Access Compliance Report Public Rights-of-Way (Curb Ramps)

Intersection ID: 43865 Main Street: SIDNEY CREST AV Cross Street: STONE TRAIL RD Location: Ν **Overall Compliance: No Severity Score:** ADA ID: 03BB5CA29F9A Ramp Type: BlendTrans1 Initial Pass/Fail: Fail 8.75

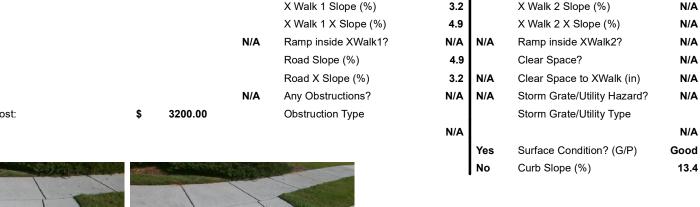
N/A
		N/A
		N/A
PROW/ADA:		N/A
Not Found, R304.5.1		N/A
		N/A
		N/A
		N/A
Total Cost:	\$ 3200.00

SIDNEY CREST AV Street 1 Name Stop Condition-Street 1 None N/A Street 2 Name Stop Condition-Street 2 N/A Remove & Replace Curb Ramp With Two New Directional Ramps or Equivalent.
